**JINDAL ALUMINIUM LTD.**  
BANGALORE-560073 (INDIA)

NAME	DATE
DRAWN	PARVESH	23-01-2014
CHECKED		
APPROVED	S.S.GARG	14-02-2014
SCALE		2:1
AREA mm <sup>2</sup>		491.973
PERIMETER mm.		103.044
WEIGHT kg/m		1.328
DRAWING No.		SECTION No.
P-13002		-
S3859		S3859 (ISSUE-3)
13591		13591

PARTY'S NAME SUBROS LTD., GURGAON

DESCRIPTION ROUND TUBE

S3859

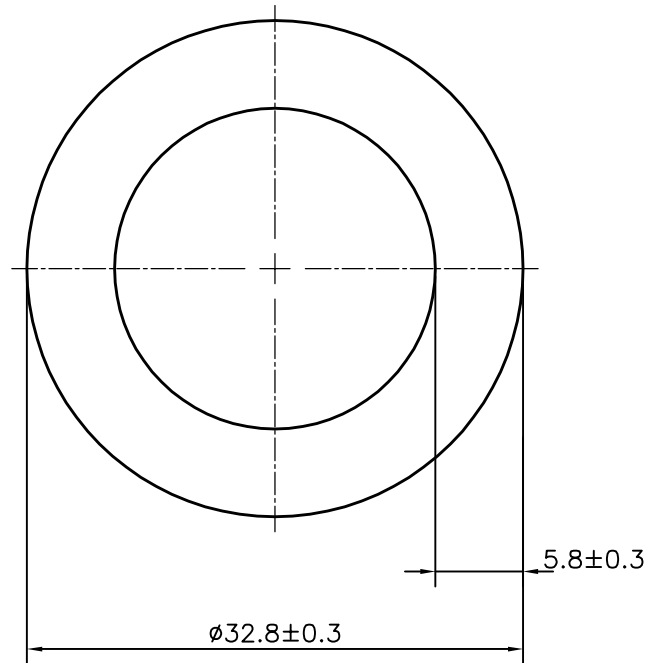
**ISSUE-2 :-**

- ☞ OD DIMENSION CHANGE FROM  $\phi 32$  TO  $\phi 32.8$ mm.
- ☞ THICKNESS CHANGED FROM 5.6 TO 6 mm.
- ☞ WEIGHT ALSO CHANGED FROM 1.254 TO 1.364 Kg/m.

**ISSUE-3 :-**

- ☞ THICKNESS CHANGED FROM 6 TO 5.8 mm.
- ☞ WEIGHT ALSO CHANGED FROM 1.364 TO 1.328 Kg/m.
